## HISTORIC AND DESIGN REVIEW COMMISSION

**HDRC CASE NO:** 2016-092  
**ADDRESS:** 918 HAYS ST  
**LEGAL DESCRIPTION:** NCB 1657 BLK E LOT W 50 FT OF 5  
**ZONING:** R5 H  
**CITY COUNCIL DIST.:** 2  
**DISTRICT:** Dignowity Hill Historic District  
**APPLICANT:** Mary Elizabeth Douglas  
**OWNER:** Mary Elizabeth Douglas  
**TYPE OF WORK:** Tax Certification  
**REQUEST:**

The applicant is requesting Historic Tax Certification for the property at 918 Hays Street.

HISTORIC AND DESIGN REVIEW COMMISSION  
CERTIFICATE OF APPROPRIATENESS

Proposed Roof

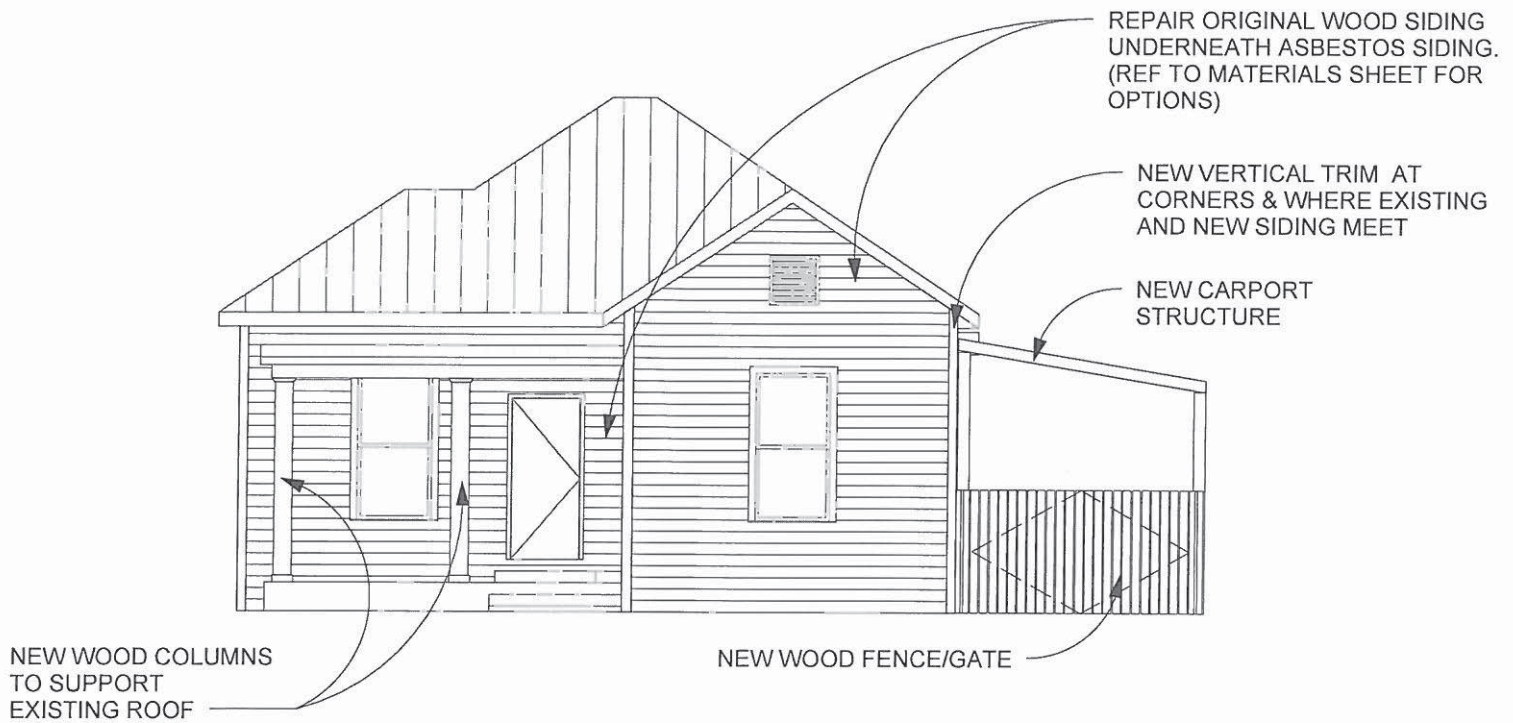
- d. This current standing seam metal roof is a character-defining feature of this property. While the proposed asphalt shingles are not inappropriate for the house, staff finds that repair of the standing seam metal should be attempted first. This is consistent with the Guidelines for Exterior Maintenance and Alterations 3.A.i. The applicant may present additional information at the public hearing to indicate the feasibility of such repairs.

1. Staff recommends approval of the rear addition based on finding b with the stipulation that vinyl siding not be used based on finding c.
2. Staff does not recommend approval of roof replacement at this time. Staff recommends repairs based on finding d.

Ext. Elevations

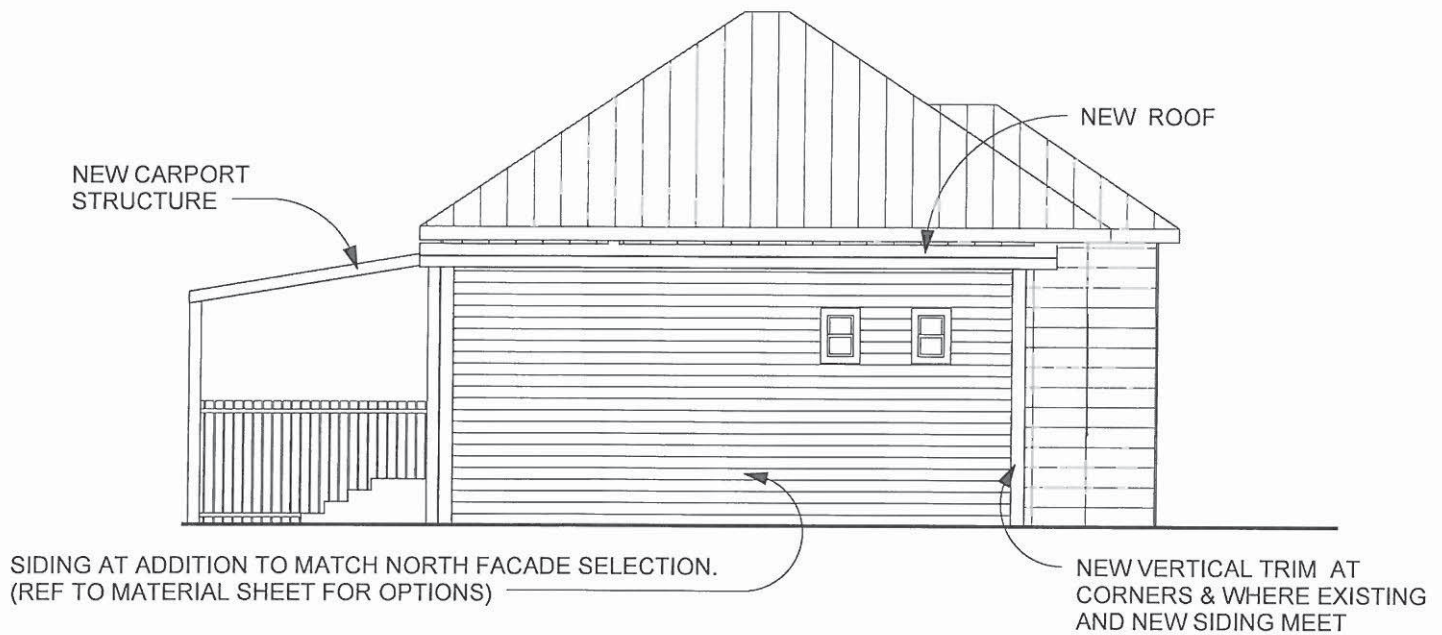
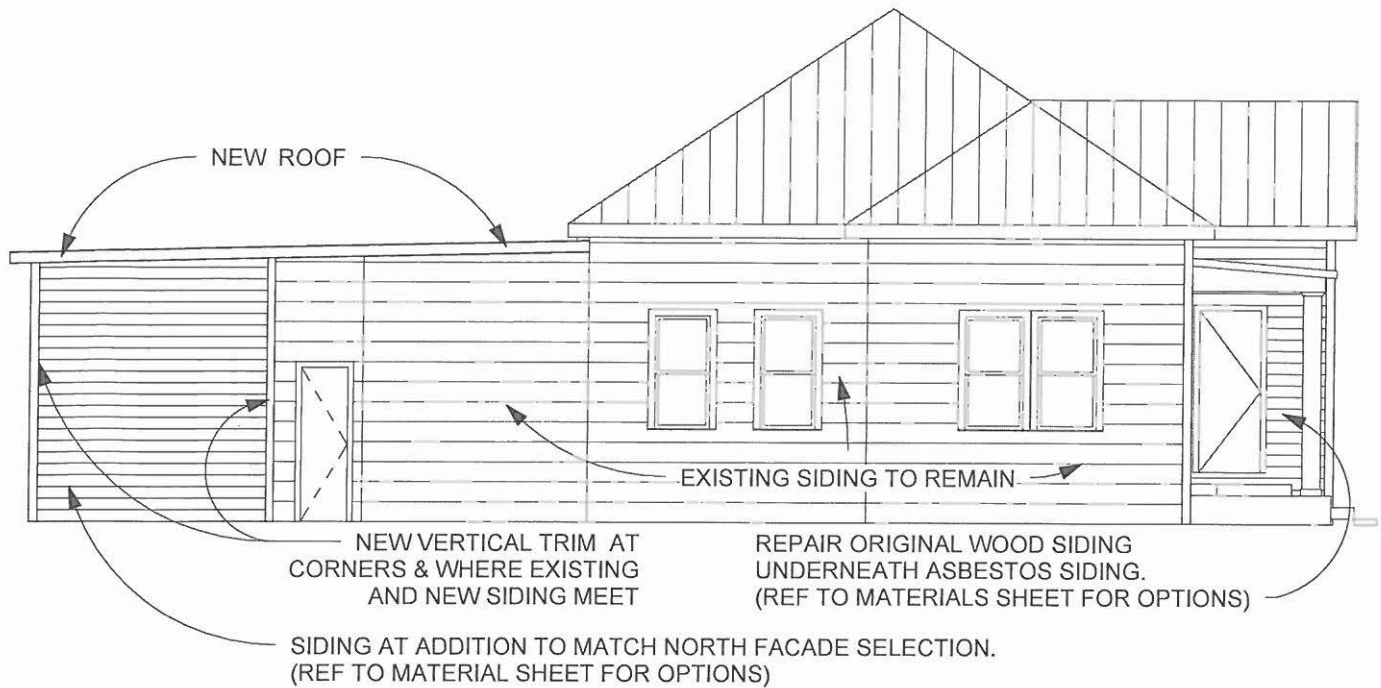
- c. According to the Guidelines for Additions 3.B.i., synthetic siding materials, such as vinyl, should not be used on additions. Appropriate siding materials, such as wood siding or Hardie siding installed to mimic the appearance of wood, would be more consistent with the Guidelines.

f. Many Victorian homes from this construction period feature two front doors. This configuration is a character-defining feature of the house and should be maintained. While the actual doors do not appear original, the door openings should be preserved in keeping with the Guidelines for Exterior Maintenance and Alterations 6.A.i.. It would be appropriate to install a period-appropriate door at this location that is fixed in place and sealed from the interior.

g. The original porch has been removed and two metal columns installed in place of wood columns. While reintroducing a wood column to the porch is appropriate, staff finds that this porch would have originally featured two columns. Both columns should be reintroduced in keeping with the Guidelines for Exterior Maintenance and Alterations 7.B.v.

4. Staff does not recommend approval of infilling the front door based on finding f.
5. Staff recommends approval of replacing the metal columns with wood with the stipulation that two columns are reintroduced to the porch instead of one based on finding g.

6. Staff does not recommend approval of the proposed vinyl siding based on finding h.
7. Staff recommends approval of window repairs as submitted based on finding i.

Ext. Elevations

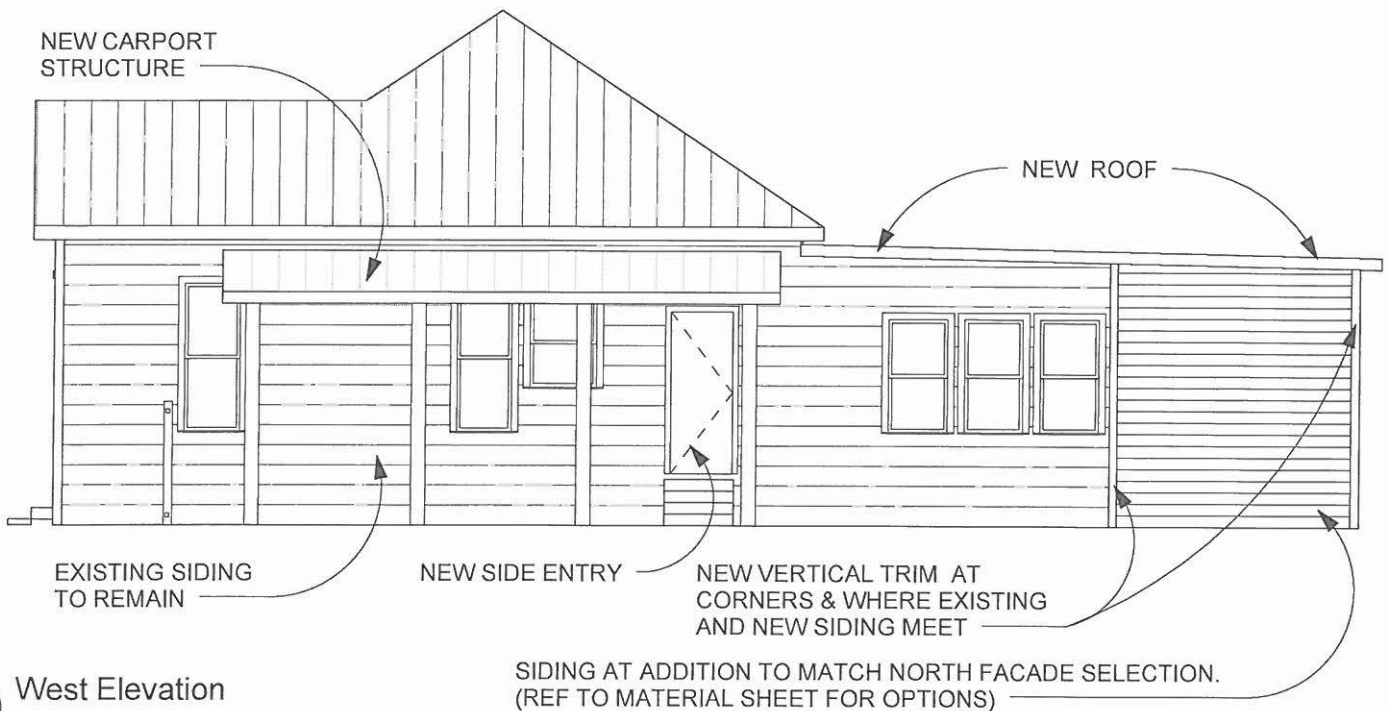
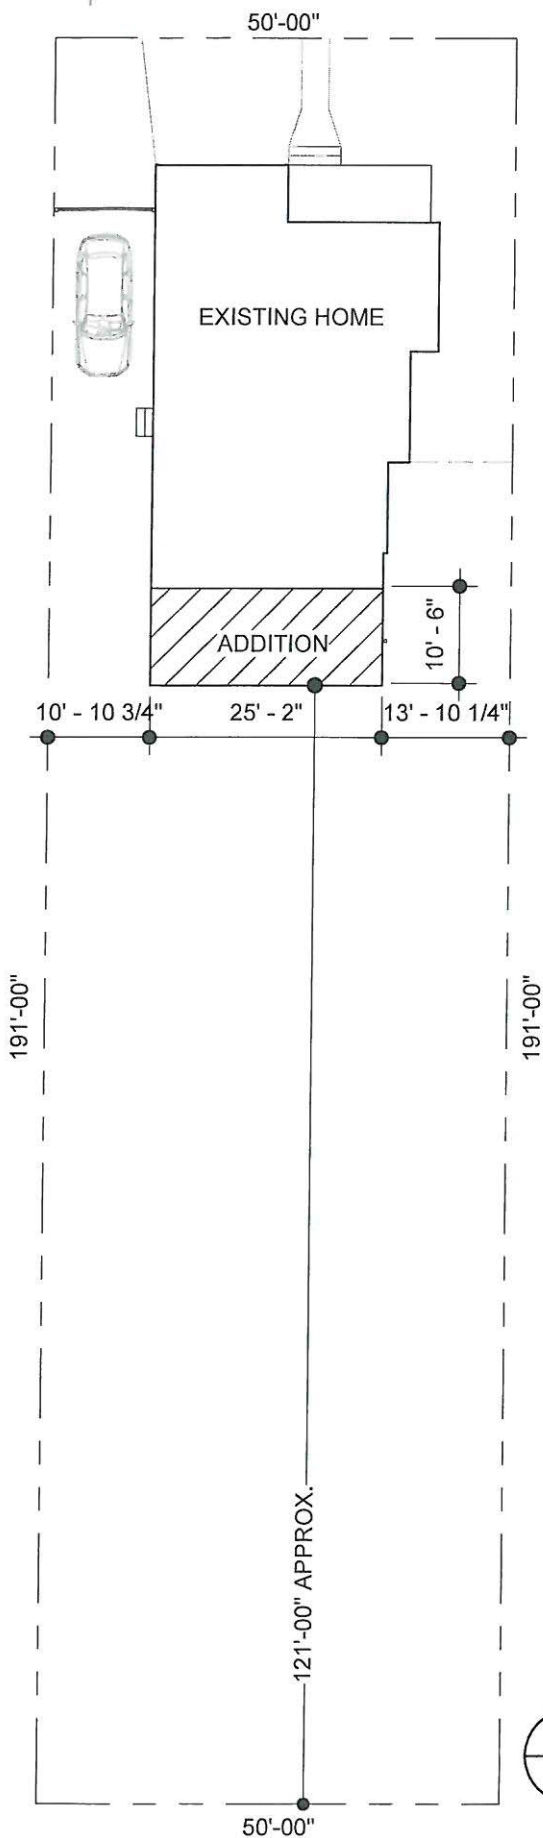
- e. The proposed carport addition is sited flush with the front plane of the house. This presents a conflict with the Guidelines for Additions 1.B.i. Staff further finds that a freestanding carport would be more appropriate as it could be able to be removed in the future without damage or modifications to the historic house.

3. Staff does not recommend approval of the carport. Staff recommends a freestanding carport sited towards the rear of the property based on finding e.

8. Staff recommends approval with the stipulation that the gate replace the existing chain link at its current location instead of aligning with the front façade of the house based on finding j.
